ADDENDUM No. 2
REQUEST FOR TENDER No. Doc5098158970
CONTRACT No. 25-PR-037

FOR: Bluffer's Park East Washroom Improvements and Exterior Works

- R1.** Replace Drawings E101, E201, E301, E401, E501 & E601 with the attached revised drawings issued with this Addendum.

Drawing Title
**GROUND FLOOR PLAN -
LIGHTING PLAN**

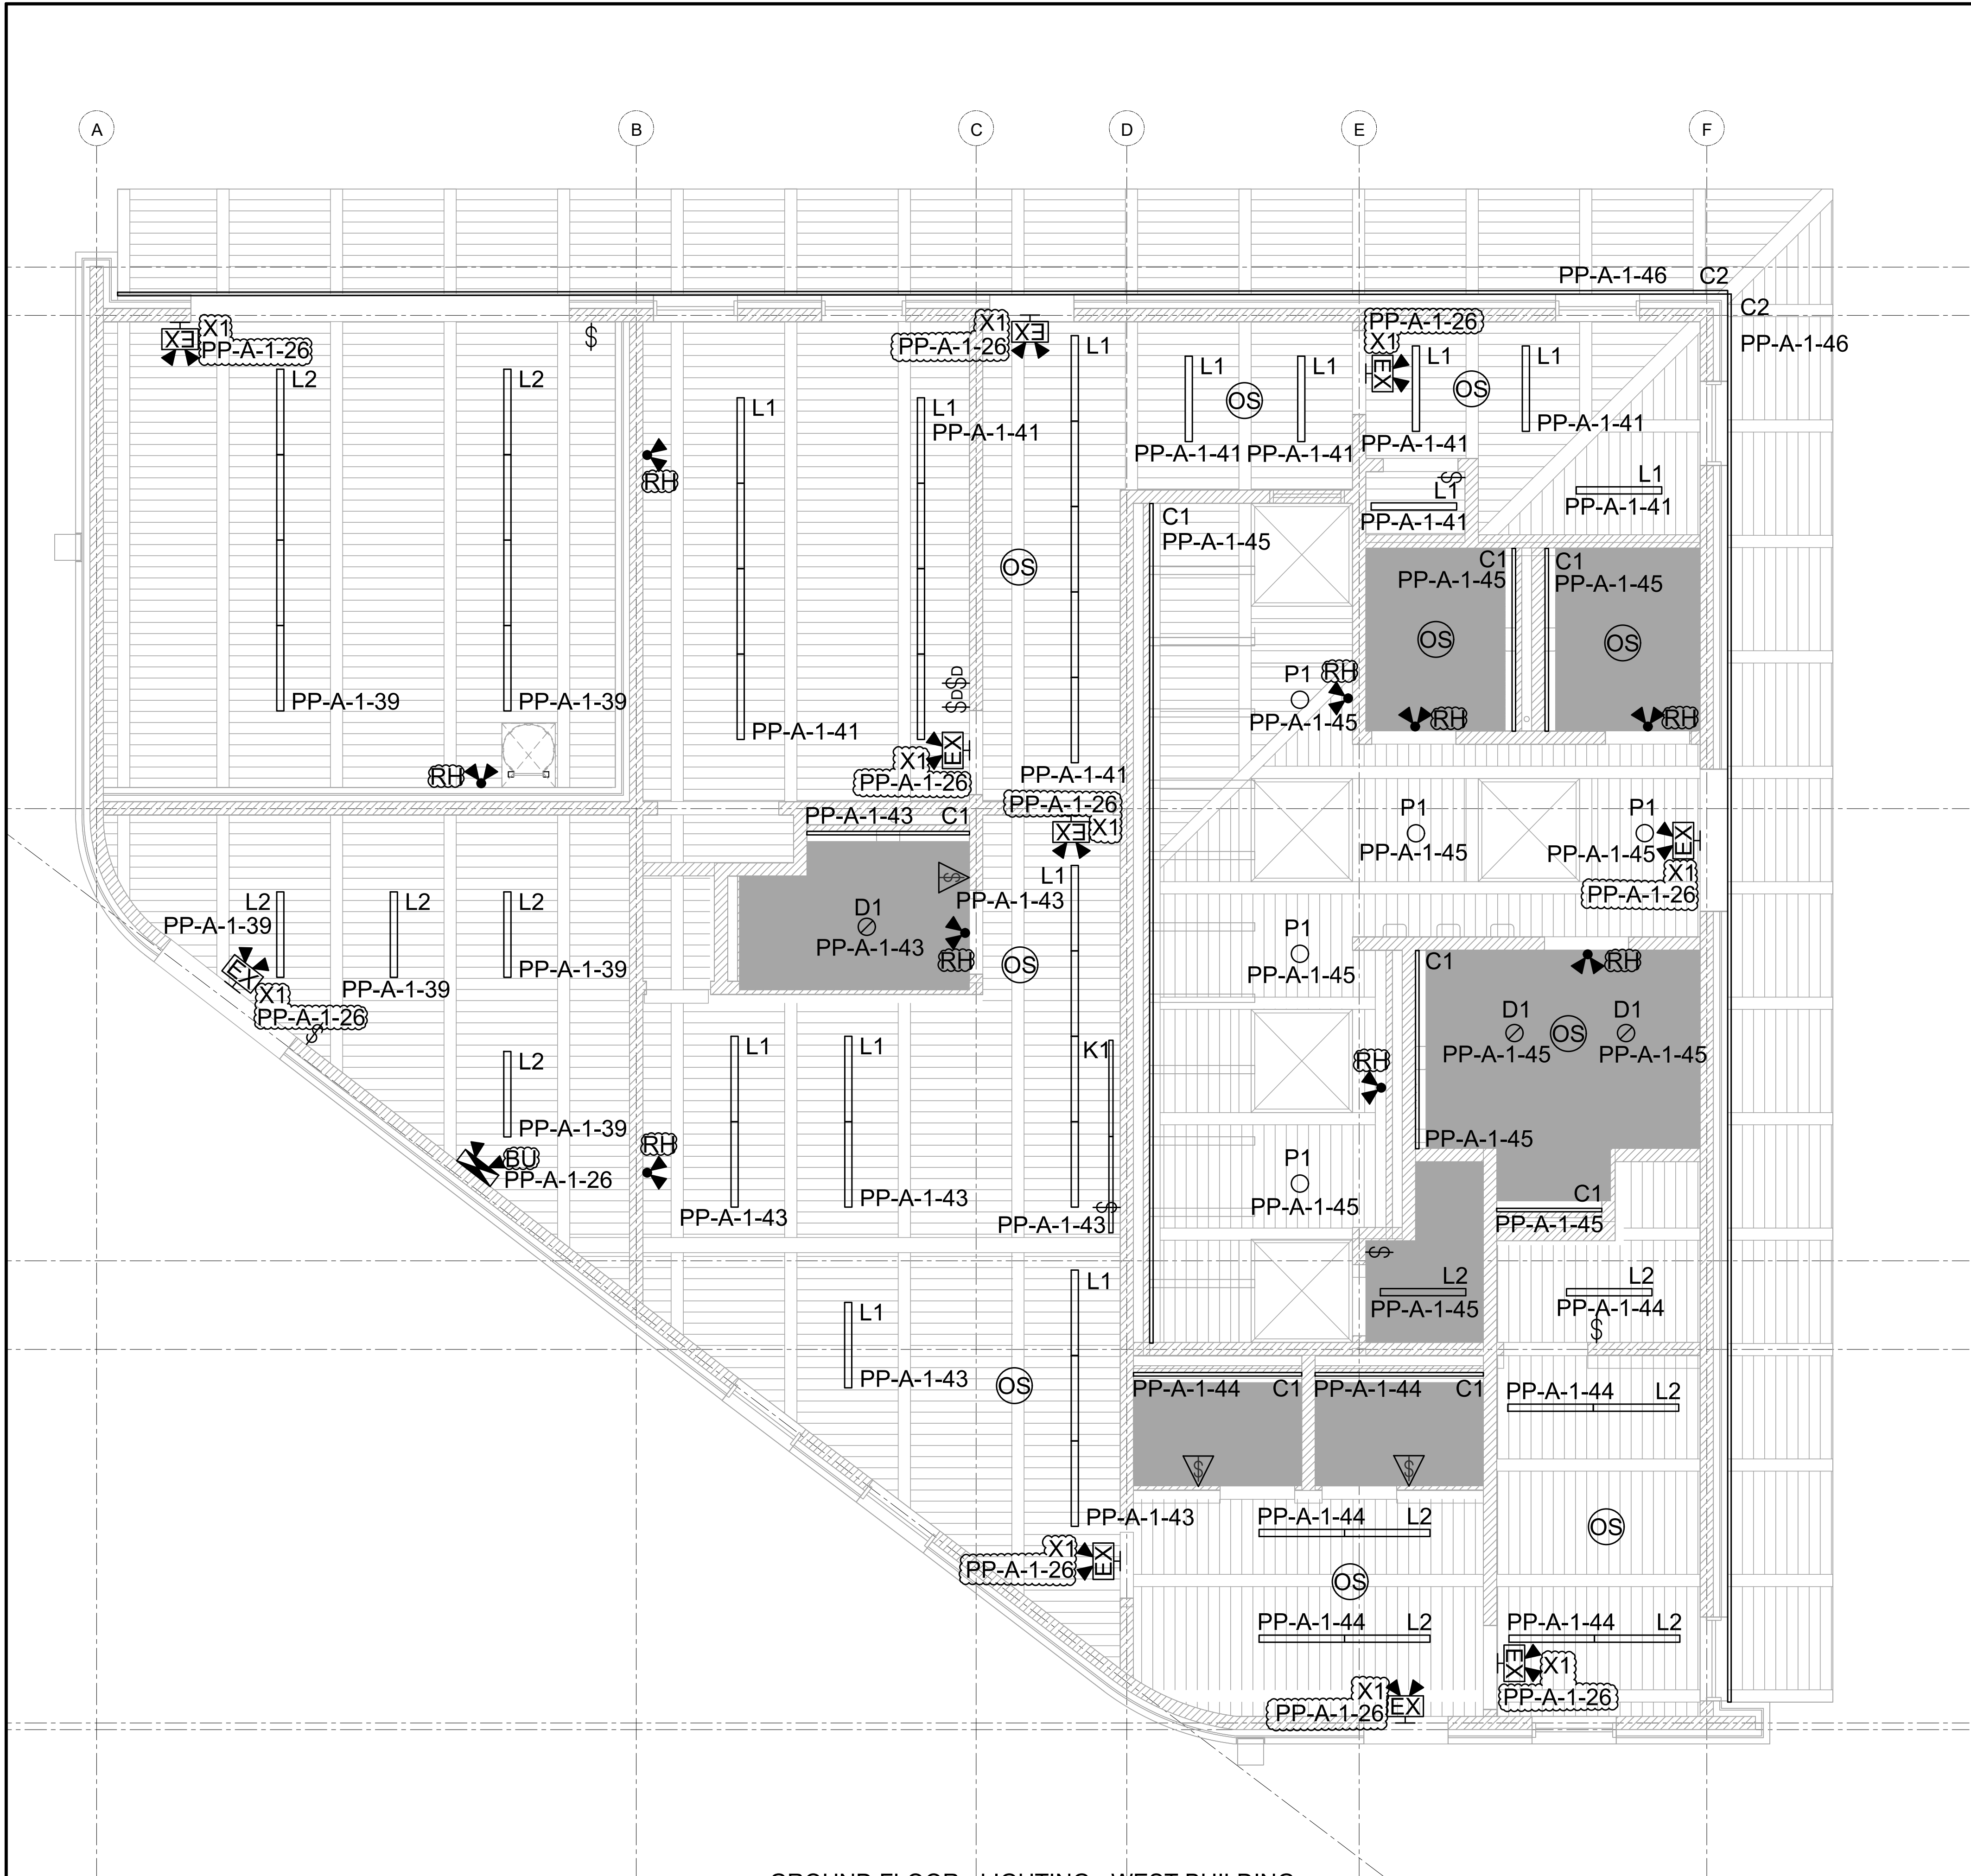
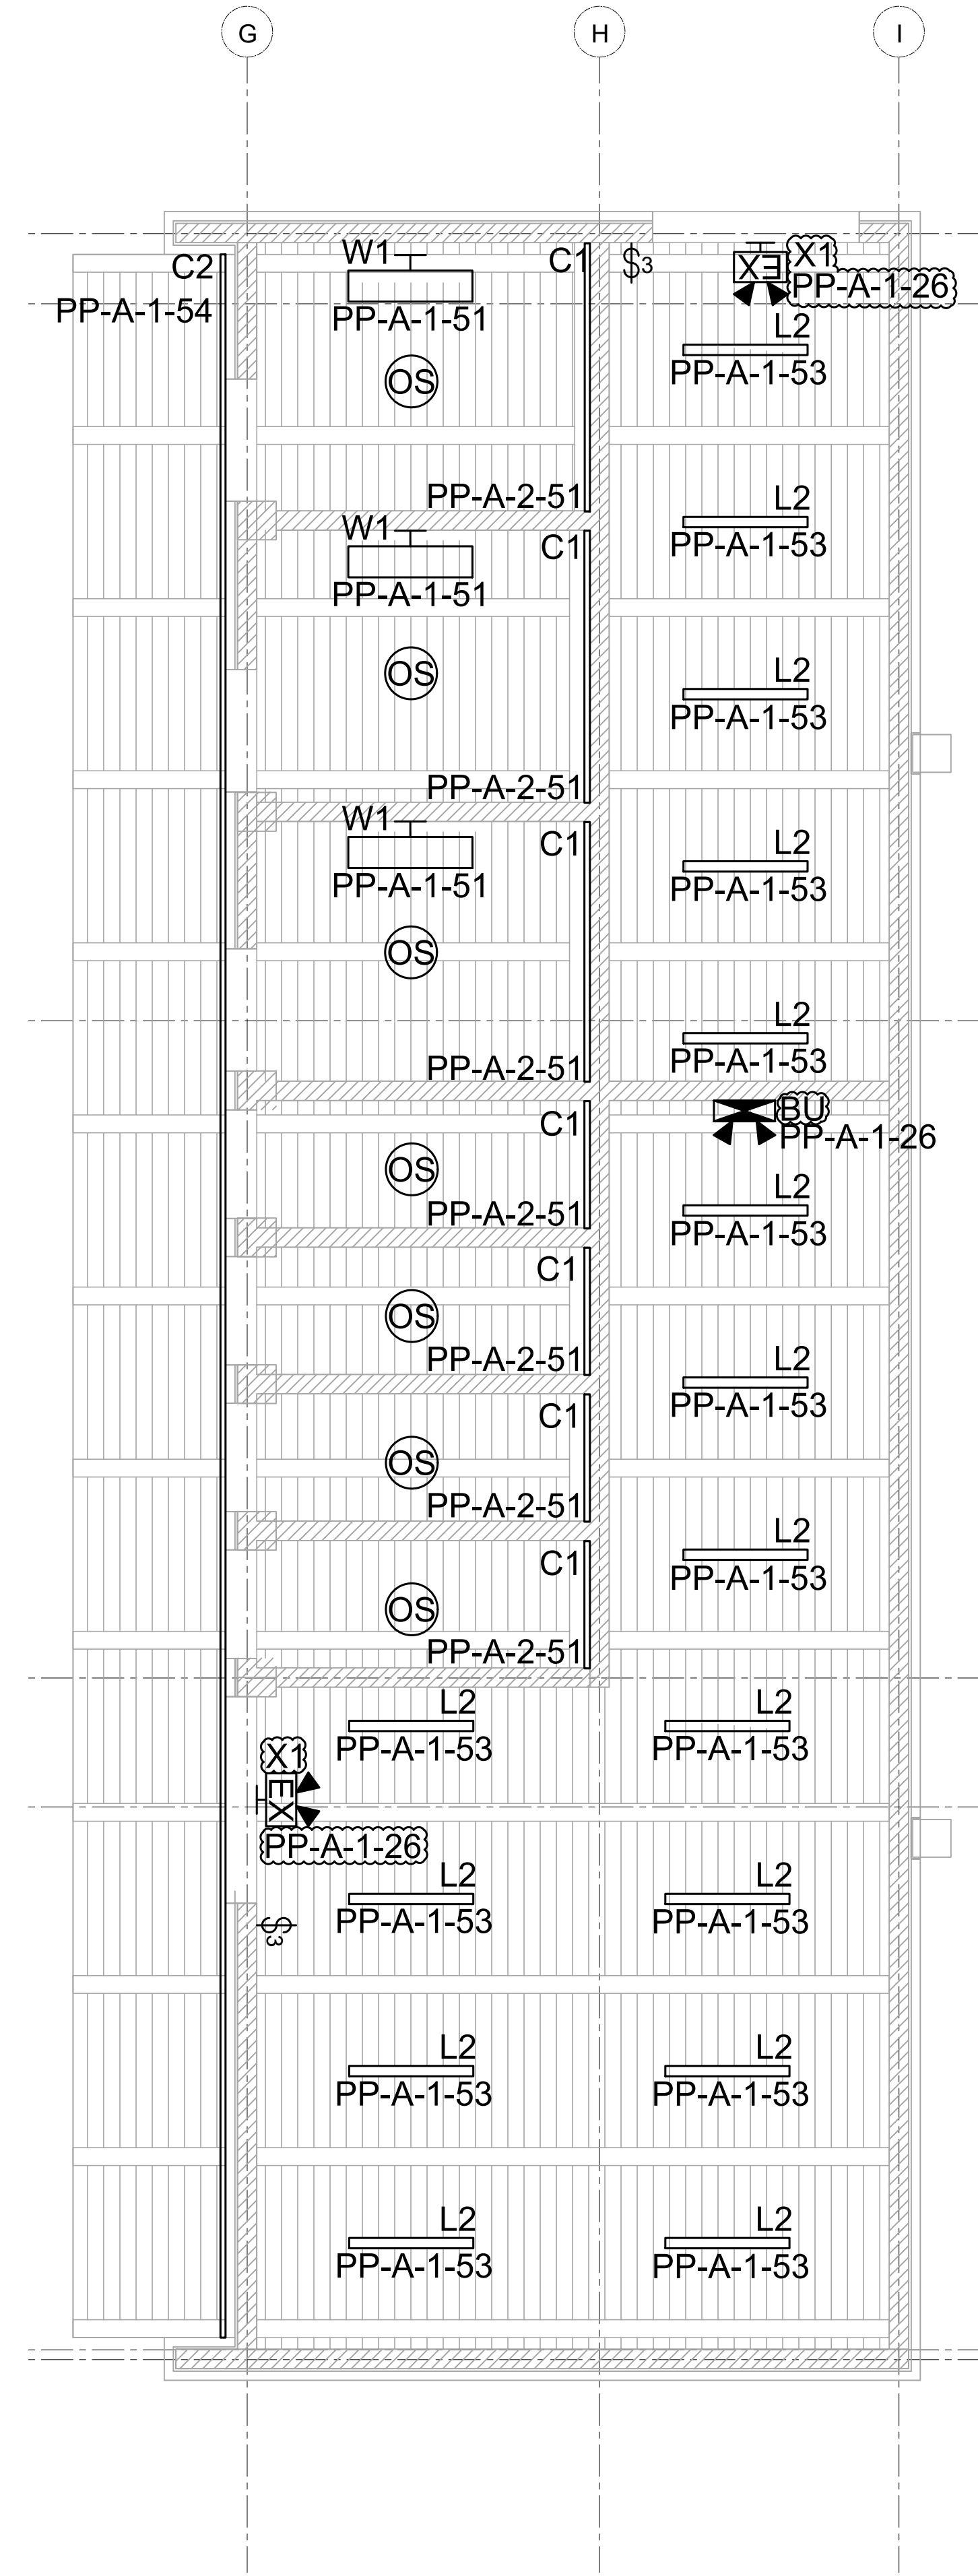
1.2 E201 – GROUND FLOOR – LIGHTING PLAN

- a. Added tags for remote heads RH.
- b. Added tags for battery units BU.
- c. Added tags and circuits for exit signs X1.
